Quality Assurance and Source Inspection

Contract #: 04-0120F4Cty: SF/ALA Rte: 80 PM: 13.2/13.9File #: 69.25B**QUALITY ASSURANCE -- NON-CONFORMANCE REPORT****Location:** Changxing Island, Shanghai, P.R. China**Report No:** NCR-000884**Prime Contractor:** American Bridge/Fluor Enterprises, a JV**Date:** 01-Nov-2010**Submitting Contractor:** Zhenhua Port Machinery Company, Ltd (ZPMC), Changxing Island**NCR #:** ZPMC-0846**Type of problem:**

Reference Description: ZPMC performed weld repair without following the WRR for bikepath BK004A2-054; subsequently, alternating the weld detail from the approved shop drawings

Job Name: SAS Superstructure
Document No: 05.03.06-000842

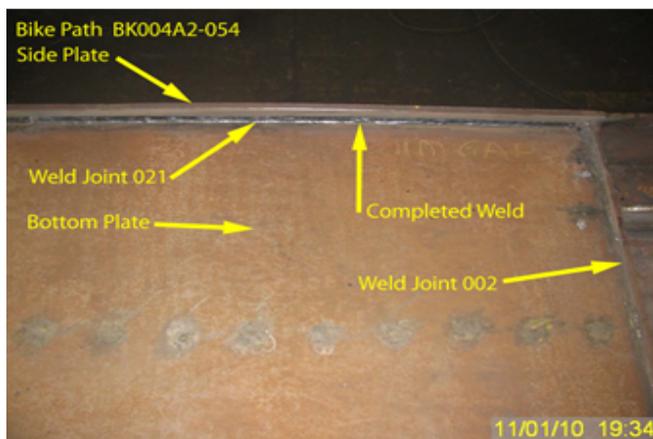
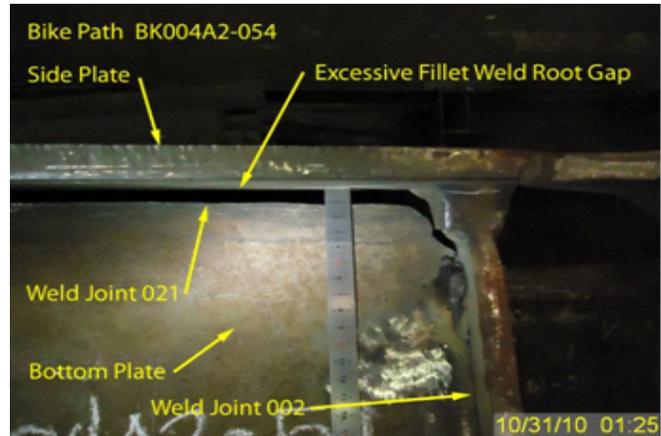
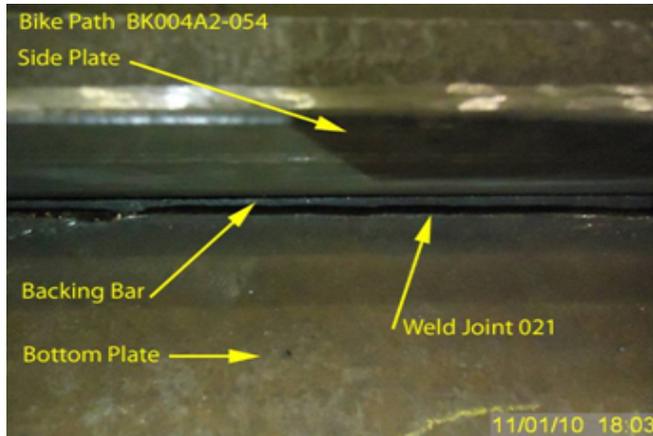
During Quality Assurance (QA) random in-process observations of the fabrication of Bike Path Segment BK004A2-054, this Caltrans QA inspector discovered the following issues:

- The bottom cover plate is distorted
- At 2 corner sections of the cover plate (1500mm and 2000mm sections), there exist root gaps of maximum 11mm.
- ZPMC personnel had a WRR# is B-WR 15580, which is for the weld build up.

- According to the approved shop drawing this weld is 6 mm fillet weld.
- ZPMC proceeded with fabrication by changing the joint detail to complete joint penetration (CJP) with backing bar to be remained rather than what it is in the WRR.

- These 2 CJP weld only cover the 1500mm and 2000mm sections, thus not a continuous CJP weld.
- Excessive root gap of more than 5mm at fit-up of CJP were measured at the bottom plate to side.

- The added tack welds on the CJP backing bar was not inspected by MT.
- The member is identified as Bike Path Segment BK004A2-054.
- The weld is fillet weld identified as BK004A2-054-021, joining BKPL4B to BKPL3B.

- The weld joins the bottom plate edge to side plate.
- OBG Bike Path is located in Bay-8.

ZPMC acknowledges that the fillet weld was changed to a CJP, they have issued an internal NCR and discussed this matter with their production crews to prevent future occurrences. In this case the CJP was welded between 6mm plates so ZPMC is providing MT results to show that the welds is acceptable as well as NDT of the base metal repair. Based on this ZPMC requests closure of this NCR.

Provide joint change detail to document a section of the weld that was partially performed without following the approved shop drawings.

Reference Description: ZPMC performed weld repair without following the WRR for bikepath BK004A2-054; subsequently, alternating the weld detail from the approved shop drawings

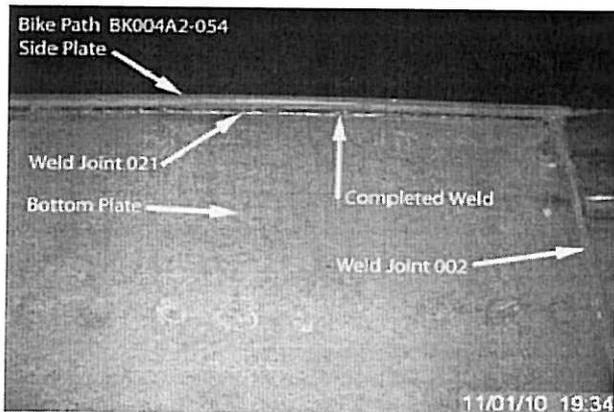
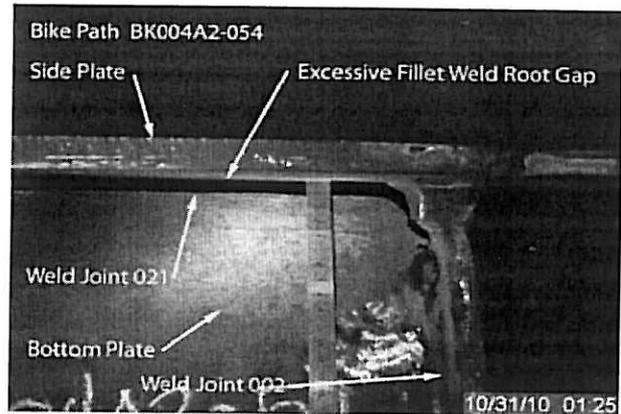
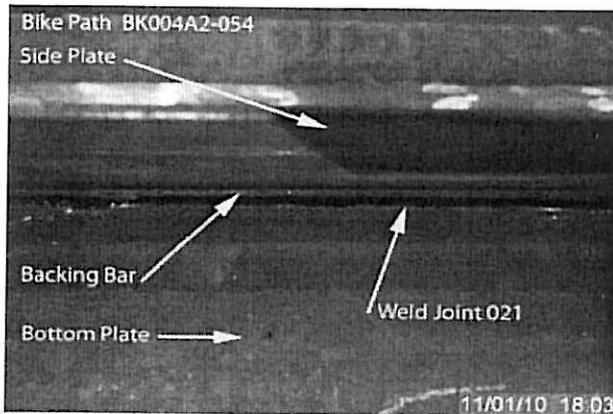
During Quality Assurance (QA) random in-process observations of the fabrication of Bike Path Segment BK004A2-054, this Caltrans QA inspector discovered the following issues:

- The bottom cover plate is distorted
- At 2 corner sections of the cover plate (1500mm and 2000mm sections), there exist root gaps of maximum 1mm.
- ZPMC personnel had a WRR# is B-WR 15580, which is for the weld build up.

- According to the approved shop drawing this weld is 6 mm fillet weld.
- ZPMC proceeded with fabrication by changing the joint detail to complete joint penetration (CJP) with backing bar to be remained rather than what it is in the WRR.

- These 2 CJP weld only cover the 1500mm and 2000mm sections, thus not a continuous CJP weld.
- Excessive root gap of more than 5mm at fit-up of CJP were measured at the bottom plate to side.

- The added tack welds on the CJP backing bar was not inspected by MT.
- The member is identified as Bike Path Segment BK004A2-054.
- The weld is fillet weld identified as BK004A2-054-021, joining BKPL4B to BKPL3B.

- The weld joins the bottom plate edge to side plate.
- OBG Bike Path is located in Bay-8.

Reference Description: ZPMC performed weld repair without following the WRR for bikepath BK004A2-054; subsequently, alternating the weld detail from the approved shop drawings

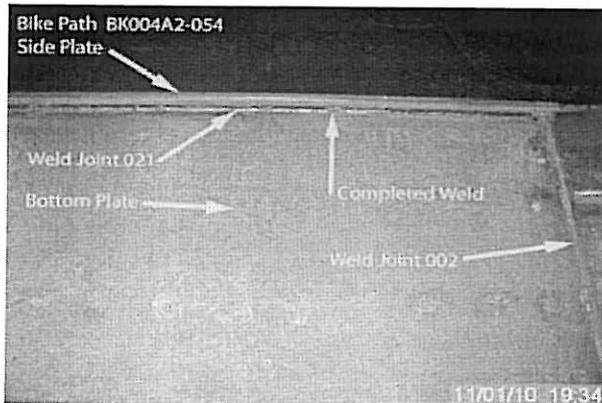
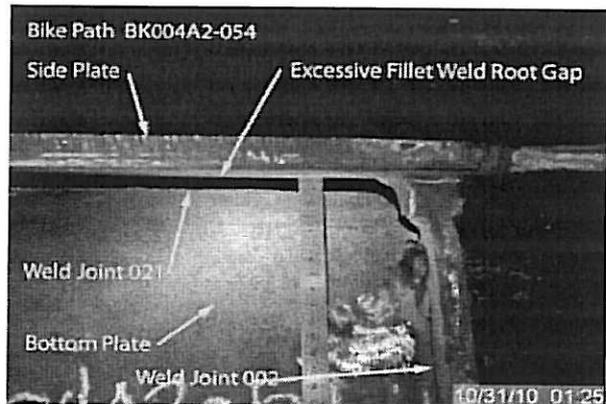
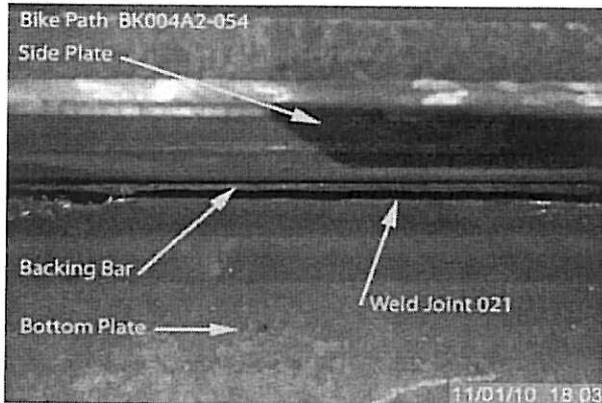
During Quality Assurance (QA) random in-process observations of the fabrication of Bike Path Segment BK004A2-054, this Caltrans QA inspector discovered the following issues:

- The bottom cover plate is distorted
- At 2 corner sections of the cover plate (1500mm and 2000mm sections), there exist root gaps of maximum 11mm.
- ZPMC personnel had a WRR# is B-WR 15580, which is for the weld build up.

- According to the approved shop drawing this weld is 6 mm fillet weld.
- ZPMC proceeded with fabrication by changing the joint detail to complete joint penetration (CJP) with backing bar to be remained rather than what it is in the WRR.

- These 2 CJP weld only cover the 1500mm and 2000mm sections, thus not a continuous CJP weld.
- Excessive root gap of more than 5mm at fit-up of CJP were measured at the bottom plate to side.

- The added tack welds on the CJP backing bar was not inspected by MT.
- The member is identified as Bike Path Segment BK004A2-054.
- The weld is fillet weld identified as BK004A2-054-021, joining BKPL4B to BKPL3B.

- The weld joins the bottom plate edge to side plate.
- OBG Bike Path is located in Bay-8.

WELDING MAP

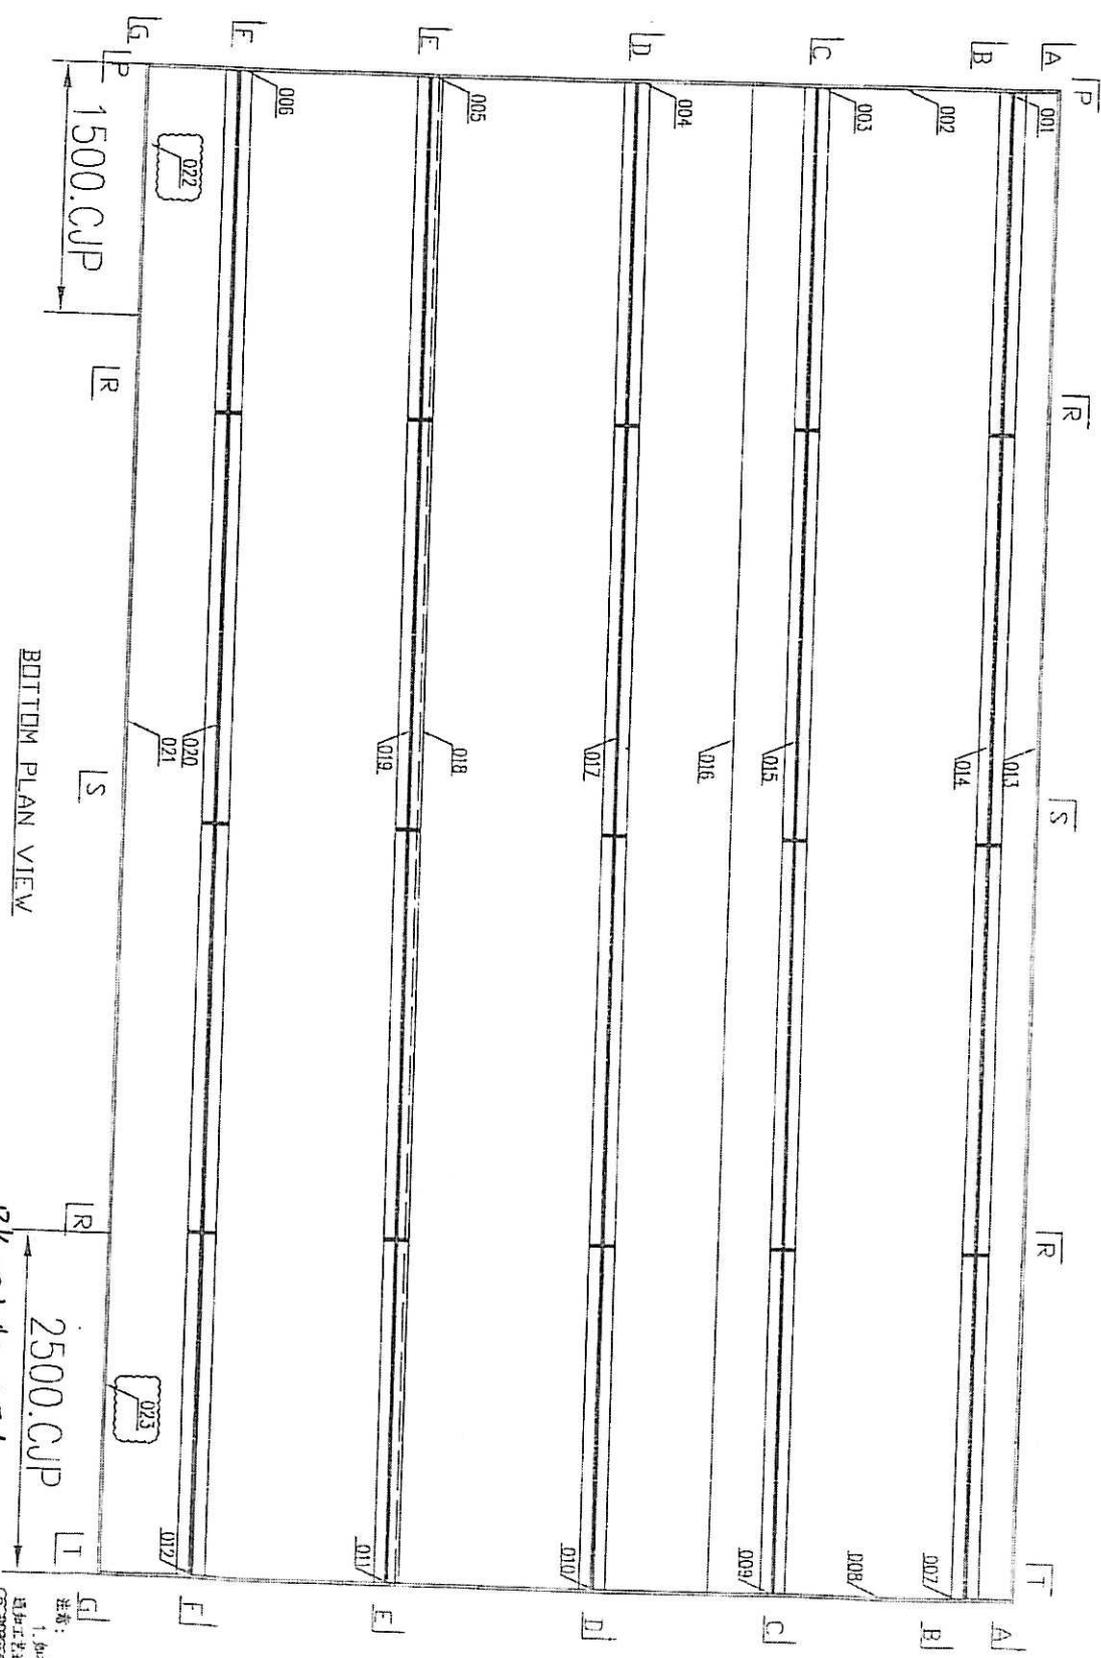
Reference Resolution: ZPMC is submitting the NDT of the CJP weld which shows it is acceptable as well as the revised weld map to show the addition of the weld joint.

Provided the new weld map.
Completed the welding with subsequent NDT.
Acceptable NDT records provided.
